SUBJECT
Airbag Warning Lamp Illuminated
MODEL

F30H (ActiveHybrid3)

Produced to 6/30/14

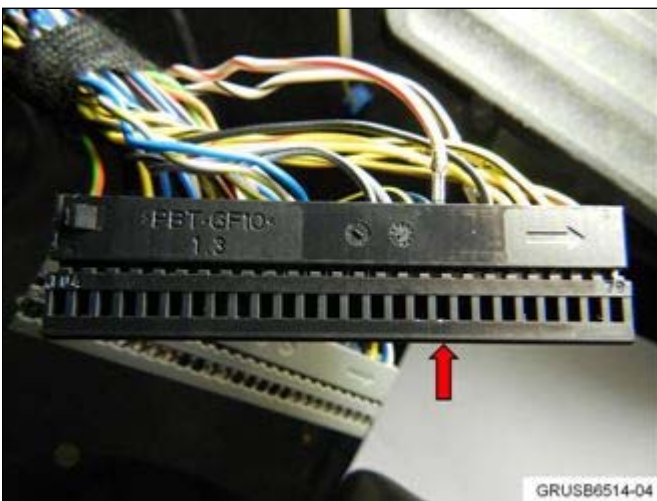
Note: Removal of the ACSM control module is not required for this repair. Once the ACSM control module is accessible, remove the blue 104-pin connector A11*1B.

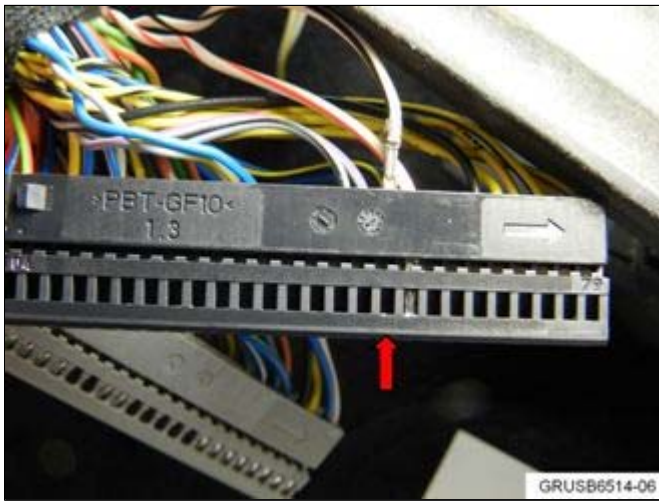
Remove the blue housing of connector A11*1B to expose the black and grey sub-connectors.

Remove pin 41 (WS/RT) of the grey sub-connector. Install it in the location of pin 87 (BL) of the black sub-connector.

Note: It is important to install the relocated pins in the correct location; otherwise, various other ACSM faults will set.

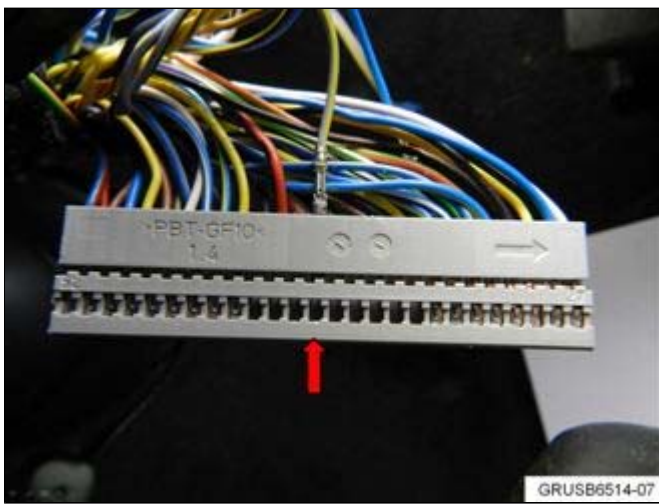
Install pin 87 (BL) of the black sub-connector in the location of pin 41 (WS/RT) of the grey sub-connector.
